Roof Safety Report

Galleria, WA 6062

Prepared By: Safemaster Safety Products
Date: 08-09-2020

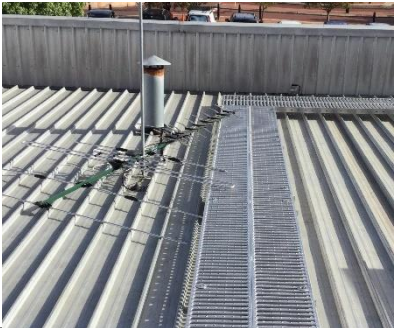
No	Photo of Hazard	Details of Hazard	Details of Risk	Existing/ Immediate Control Measure	Curre nt Risk Level	Proposed Permanent Solution	Resid ual Risk Asse ssme nt	Details of Action Taken	Status	Reference
20	Building: General Stores Location Reference: L17 Task: Access to the A/c unit									
		Bottom rung height is less than required minimum and landing is less than required minimum	Trips, Slips and Falls	Awareness induction	Med	Existing ladder to be removed and New parapet ladder including landing platforms to be installed	Low	Client advised	Outstanding	OH&S REGULATIONS 3.7 AS/NZS 1657-2013 7.4.3.4 & 7.3.6

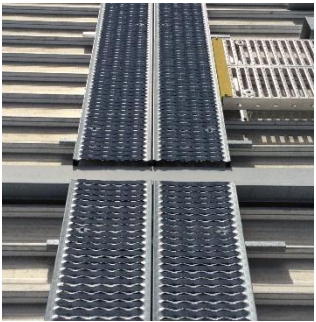
No	Photo of Hazard	Details of Hazard	Details of Risk	Existing/ Immediate Control Measure	Curre nt Risk Level	Proposed Permanent Solution	Resid ual Risk Asse ssme nt	Details of Action Taken	Status	Reference
21	Building: General Stores Location Reference: L18 Task: Access to the A/c unit									
		Variation in height between two levels are greater than required maximum	Trips, Slips and Falls	Awareness induction	Med	High visibility safety yellow tape to be installed	Low	Client advised	Outstanding	OH&S REGULATIONS 3.6 AS/NZS 1657-2013 3.3.4
22	Building: General Stores Location Reference: L19 Task: Access to the A/c unit									
		Gap between the walkway panels are greater than required maximum	Trips, Slips and Falls	Awareness induction	Med	Bridging platform to be installed between two walkway sections including high visibility safety yellow nosing's	Low	Client advised	Outstanding	OH&S REGULATIONS 3.6 AS/NZS 1657-2013 3.2.3.4

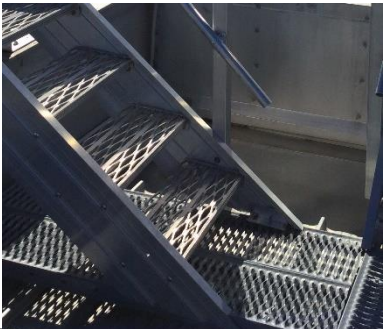
No	Photo of Hazard	Details of Hazard	Details of Risk	Existing/ Immediate Control Measure	Curre nt Risk Level	Proposed Permanent Solution	Resid ual Risk Asse sme nt	Details of Action Taken	Status	Reference
25	Building: General Stores Location Reference: L24 Task: Access to the A/c unit									
		Antenna installed over walkway	Trips, Slips and Falls	Awareness induction	Med	Walkway to be re-routed with additional sections if required or Re-locate antenna	Low	Client advised	Outstanding	OH&S REGULATIONS 3.6
26	Building: General Stores Location Reference: L25 Task: Access to the A/c unit									
		Walkway width is less than required minimum	Trips, Slips and Falls	Awareness induction	Med	Walkway to be extended	Low	Client advised	Outstanding	OH&S REGULATIONS 3.6 AS/NZS 1657-2013 5.1.3

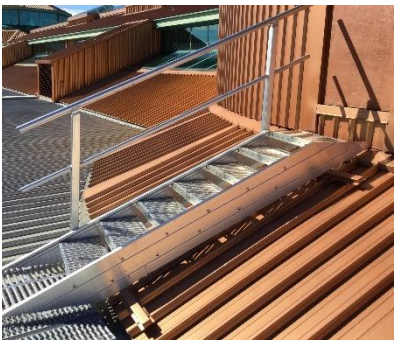
No	Photo of Hazard	Details of Hazard	Details of Risk	Existing/ Immediate Control Measure	Curre nt Risk Level	Proposed Permanent Solution	Resid ual Risk Asse sme nt	Details of Action Taken	Status	Reference
33	Building: General Stores Location Reference: L30 Task: Access to the A/c unit									
		Walkway height is greater than required maximum from the adjacent area	Trips, Slips and Falls	Awareness induction	Med	Handrails to be installed	Low	Client advised	Outstanding	OH&S REGULATIONS 3.6 AS/NZS 1657-2013 5.4.1
34	Building: General Stores Location Reference: L31 Task: Access to the A/c unit									
		Bottom tread height is less than required minimum and Handrail is missing on one side	Trips, Slips and Falls	Awareness induction	Med	New landing platform to level with the bottom tread including high visibility safety yellow nosings to be installed and walkway to be re-routed with additional sections	Low	Client advised	Outstanding	OH&S REGULATIONS 3.7 AS/NZS 1657-2013 7.2.3.2

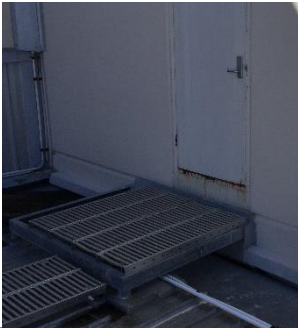
No	Photo of Hazard	Details of Hazard	Details of Risk	Existing/ Immediate Control Measure	Curre nt Risk Level	Proposed Permanent Solution	Resid ual Risk Asse ssme nt	Details of Action Taken	Status	Reference
41	Building: General Stores Location Reference: L37 Task: Access to the A/c unit									
		Roof pitch higher than the required minimum for a work area	Trips, Slips and Falls	Awareness induction	Med	Access platform and steps with handrail one side to be installed	Low	Client advised	Outstanding	OH&S REGULATIONS 3.7 AS/NZS 1657-2013 2.2
42	Building: General Stores Location Reference: L38 Task: Access to the A/c unit									
		Roof pitch higher than the required minimum for a work area	Trips, Slips and Falls	Awareness induction	Med	Access platform and steps with handrail one side to be installed	Low	Client advised	Outstanding	OH&S REGULATIONS 3.7 AS/NZS 1657-2013 2.2

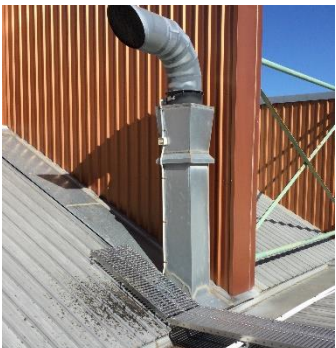
No	Photo of Hazard	Details of Hazard	Details of Risk	Existing/ Immediate Control Measure	Curre nt Risk Level	Proposed Permanent Solution	Resid ual Risk Asse ssme nt	Details of Action Taken	Status	Reference
43	Building: General Stores Location Reference: L39 Task: Access to the A/c unit									
		Roof pitch higher than the required minimum for a work area	Trips, Slips and Falls	Awareness induction	Med	Access platform and steps with handrail one side to be installed	Low	Client advised	Outstanding	OH&S REGULATIONS 3.7 AS/NZS 1657-2013 2.2
44	Building: General Stores Location Reference: L40 Task: Access to the A/c unit									
		Roof pitch higher than the required minimum for a work area	Trips, Slips and Falls	Awareness induction	Med	Access platform and steps with handrail one side to be installed	Low	Client advised	Outstanding	OH&S REGULATIONS 3.7 AS/NZS 1657-2013 2.2

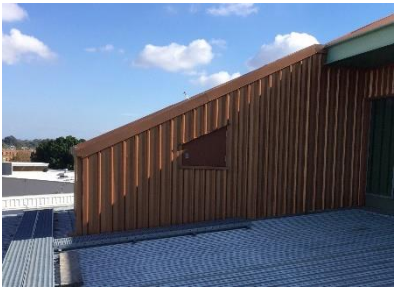
No	Photo of Hazard	Details of Hazard	Details of Risk	Existing/ Immediate Control Measure	Curre nt Risk Level	Proposed Permanent Solution	Resid ual Risk Asse ssme nt	Details of Action Taken	Status	Reference
72	Building: General Stores Location Reference: L64 Task: Access to the A/c unit									
		Handrail height at landing is less than required minimum and risers is less than required minimum	Trips, Slips and Falls	Awareness induction	Med	Exiting handrail and stair to be removed & New stair and handrail to be installed	Low	Client advised	Outstanding	OH&S REGULATIONS 3.7 AS/NZS 16572013 7.2.3.2 & 7.2.6

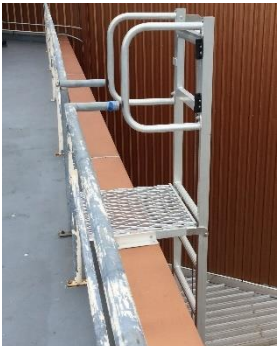
No	Photo of Hazard	Details of Hazard	Details of Risk	Existing/ Immediate Control Measure	Curre nt Risk Level	Proposed Permanent Solution	Resid ual Risk Asse ssme nt	Details of Action Taken	Status	Reference
87	Building: General Stores Location Reference: L78 Task: Access to the A/c unit									
		Roof pitch higher than the required minimum for a work area	Trips, Slips and Falls	Awareness induction	Med	Access platform and steps with handrail one side to be installed	Low	Client advised	Outstanding	OH&S REGULATIONS 3.7 AS/NZS 16572013 2.2
88	Building: General Stores Location Reference: L80 Task: Access to the A/c unit									
		Toeboard is missing on handrail sections and gap between midrail and handrail is greater than required maximum and handrail not permitting unrestricted movement of the user's hand	Trips, Slips and Falls	Awareness induction	Med	Toeboard and midrail to be installed on existing steel handrail posts and New handrail and midrail section to be installed on corners	Low	Client advised	Outstanding	AS/NZS 16572013 5.6.3 & 5.6.6 & 6.2.1.2

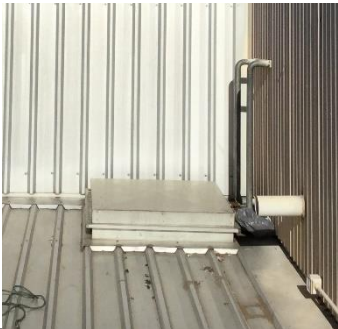
No	Photo of Hazard	Details of Hazard	Details of Risk	Existing/ Immediate Control Measure	Curre nt Risk Level	Proposed Permanent Solution	Resid ual Risk Asse ssme nt	Details of Action Taken	Status	Reference
102	Building: General Stores Location Reference: L96 Task: Access to the A/c unit									
		Duct over the walkway path	Trips, Slips and Falls	Awareness induction	Med	Walkway to be re- routed	Low	Client advised	Outsta nding	OH&S REGULATIONS 3.6 AS/NZS 16572013 4.1.3
104	Building: General Stores Location Reference: L98 Task: Access to the A/c unit									
		Top rung not levelled with landing/roof and bottom rung height is less than required minimum	Trips, Slips and Falls	Awareness induction	Med	Existing ladder to be removed and New ladder including ladder support platforms to be installed	Low	Client advised	Outsta nding	OH&S REGULATIONS 3.7 AS/NZS 16572013 7.4.3.3 & 7.4.3.4

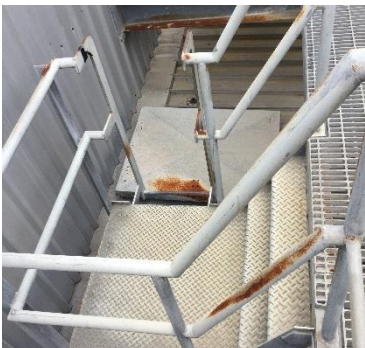
No	Photo of Hazard	Details of Hazard	Details of Risk	Existing/ Immediate Control Measure	Curre nt Risk Level	Proposed Permanent Solution	Resid ual Risk Asse ssme nt	Details of Action Taken	Status	Reference
111	Building: General Stores Location Reference: L105 Task: Access to the A/c unit									
		Hatch not in service	Trips, Slips and Falls	Awareness induction	Med	"OUT OF SERVICE" sign to be installed	Low	Client advised	Outstanding	OH&S REGULATIONS 3.11
112	Building: General Stores Location Reference: L105 Task: Access to the A/c unit									
		No slip resistance on ladder rungs and top rung not levelled with landing and in-correct installation of handrails	Trips, Slips and Falls	Awareness induction	Med	Existing ladder and handrail to be removed and new ladder including landing platforms and handrails to be installed	Low	Client advised	Outstanding	OH&S REGULATIONS 3.7 AS/NZS 16572013 3.1.3 & 5.6.1 & 7.4.3.3

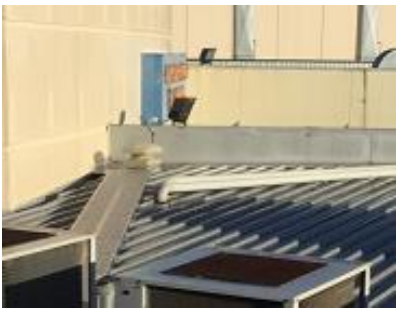
No	Photo of Hazard	Details of Hazard	Details of Risk	Existing/ Immediate Control Measure	Curre nt Risk Level	Proposed Permanent Solution	Resid ual Risk Asse ssme nt	Details of Action Taken	Status	Reference
137	Building: General Stores Location Reference: L16 Task: Access to the A/c unit									
		Gap between the walkway panels are greater than required maximum	Trips, Slips and Falls	Awareness induction	Med	Bridging platform to be installed between two walkway sections including high visibility safety yellow nosing's	Low	Client advised	Outstanding	OH&S REGULATIONS 3.7 AS/NZS 1657-2013 3.2.3.4

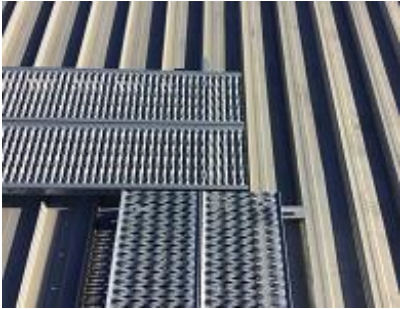
No	Photo of Hazard	Details of Hazard	Details of Risk	Existing/ Immediate Control Measure	Curre nt Risk Level	Proposed Permanent Solution	Resid ual Risk Asse sme nt	Details of Action Taken	Status	Reference
161	Building: General Stores Location Reference: L37 Task: Access to the roof									
		Variation in height between roofs are greater than required maximum	Trips, Slips and Falls	Awareness induction	Med	Access ladder including landing platforms, preformed handrails to be installed	Low	Client advised	Outstanding	OH&S REGULATIONS 3.7 AS/NZS 1657-2013 3.1.4

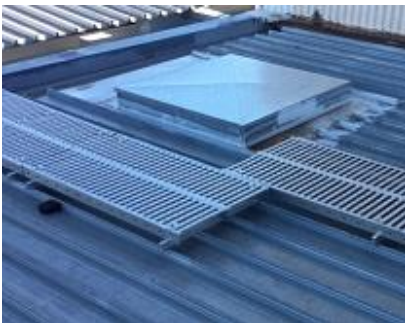
No	Photo of Hazard	Details of Hazard	Details of Risk	Existing/ Immediate Control Measure	Curre nt Risk Level	Proposed Permanent Solution	Resid ual Risk Asse ssme nt	Details of Action Taken	Status	Reference
164	Building: General Stores Location Reference: L63 Task: Access to the roof									
		No safe access to the door	Trips, Slips and Falls	Awareness induction	Med	Access platform and steps with handrail one side to be installed	Low	Client advised	Outstanding	OH&S REGULATIONS 3.7 AS/NZS 1657- 2013 3.1.4

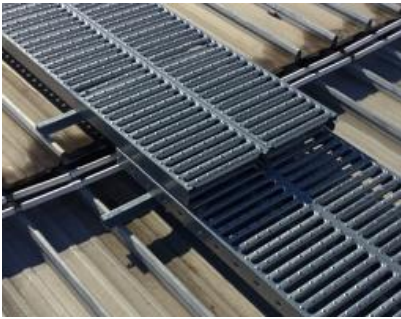
No	Photo of Hazard	Details of Hazard	Details of Risk	Existing/ Immediate Control Measure	Curre nt Risk Level	Proposed Permanent Solution	Resid ual Risk Asse sme nt	Details of Action Taken	Status	Reference
174	Building: General Stores Location Reference: L99 Task: Access to the roof									
		Missing walkway section at corner	Trips, Slips and Falls	Awareness induction	Med	Supply walkway to the A/c unit	Low	Client advised	Outstanding	OH&S REGULATIONS 3.7

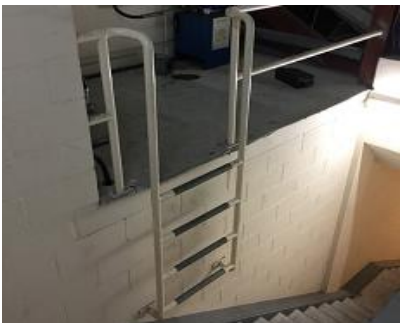
No	Photo of Hazard	Details of Hazard	Details of Risk	Existing/ Immediate Control Measure	Curre nt Risk Level	Proposed Permanent Solution	Resid ual Risk Asse sme nt	Details of Action Taken	Status	Reference
175	Building: General Stores Location Reference: L102 Task: Access to the roof									
		Walkway width at access point is less than required minimum	Trips, Slips and Falls	Awareness induction	Med	Additional walkway section to be installed	Low	Client advised	Outstanding	OH&S REGULATIONS 3.7 AS/NZS 1657-2013 5.1.3
176	Building: General Stores Location Reference: L99 Task: Access to the A/c units									
		Walkway width is less than required minimum	Trips, Slips and Falls	Awareness induction	Med	Additional walkway section to be installed	Low	Client advised	Outstanding	OH&S REGULATIONS 3.7 AS/NZS 1657-2013 5.1.3

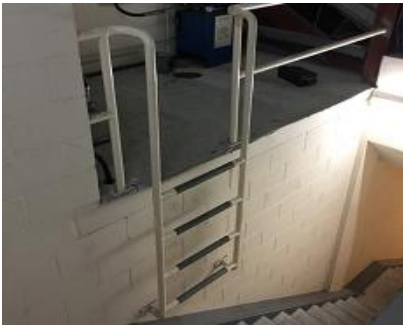
No	Photo of Hazard	Details of Hazard	Details of Risk	Existing/ Immediate Control Measure	Curre nt Risk Level	Proposed Permanent Solution	Resid ual Risk Asse ssme nt	Details of Action Taken	Status	Reference
179	Building: General Stores Location Reference: L106 Task: Access to the A/c units									
		No safe access to the A/c units	Trips, Slips and Falls	N/A	Low	Supply walkway to the A/c units	Low	Client advised	Outstanding	-
180	Building: General Stores Location Reference: L109 Task: Access to the A/c unit									
		Gap between the walkway panels are greater than required maximum	Trips, Slips and Falls	Awareness induction	Med	Walkway bridge including high visibility safety yellow nosing's to be installed	Low	Client advised	Outstanding	OH&S REGULATIONS 3.7 AS/NZS 1657-2013 3.2.3.4

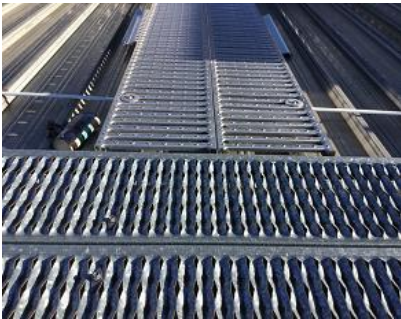
No	Photo of Hazard	Details of Hazard	Details of Risk	Existing/ Immediate Control Measure	Current Risk Level	Proposed Permanent Solution	Residual Risk Assessment	Details of Action Taken	Status	Reference
186	Building: General Stores Location Reference: L02 Task: Access to the roof									
		Toe board is missing for guardrail	Trips, Slips and Falls	Awareness induction	Med	Toe board and self-closing gate to be installed	Low	Client advised	Outstanding	OH&S REGULATIONS 3.7 AS/NZS 1657-2018 4.6
187	Building: General Stores Location Reference: L05 Task: Access to the A/c units									
		No safe access to the A/c units	Trips, Slips and Falls	N/A	Low	Supply walkway to the A/c units	Low	Client advised	Outstanding	-

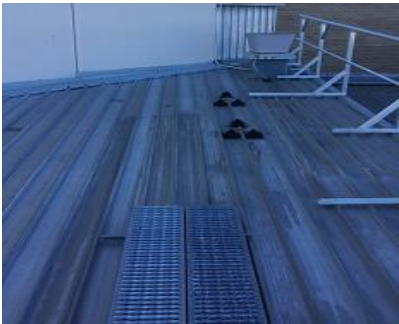
No	Photo of Hazard	Details of Hazard	Details of Risk	Existing/ Immediate Control Measure	Curre nt Risk Level	Proposed Permanent Solution	Resid ual Risk Asse ssme nt	Details of Action Taken	Status	Reference
192	Building: General Stores Location Reference: L14 Task: Access to the roof									
		Variation in height between walkway panels are greater than required maximum	Trips, Slips and Falls	Awareness induction	Med	High visibility safety yellow nosing's to be installed	Low	Client advised	Outstanding	OH&S REGULATIONS 3.7 AS/NZS 1657-2018 3.3.4
193	Building: General Stores Location Reference: L15 Task: Access to the roof									
		Variation in height between walkway panels are greater than required maximum	Trips, Slips and Falls	Awareness induction	Med	High visibility safety yellow nosing's to be installed	Low	Client advised	Outstanding	OH&S REGULATIONS 3.7 AS/NZS 1657-2018 3.3.4

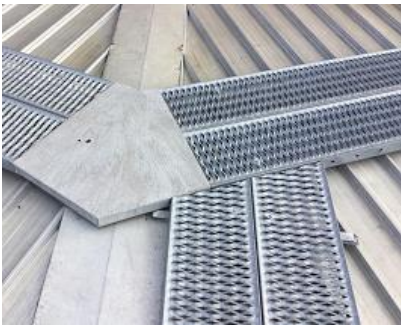
No	Photo of Hazard	Details of Hazard	Details of Risk	Existing/ Immediate Control Measure	Curre nt Risk Level	Proposed Permanent Solution	Resid ual Risk Asse sme nt	Details of Action Taken	Status	Reference
23 6	Building: General Stores Location Reference: L115 Task: Access to the A/c units									
		No safe access to the A/c units	Trips, Slips and Falls	N/A	Low	Supply walkway to the A/c units	Low	Client advised	Outstanding	-
23 7	Building: General Stores Location Reference: L118 Task: Access to the roof									
		Variation in height between walkway panels are greater than required maximum	Trips, Slips and Falls	Awareness induction	Med	High visibility safety yellow nosing's to be installed	Low	Client advised	Outstanding	OH&S REGULATIONS 3.7 AS/NZS 1657-2018 3.3.4
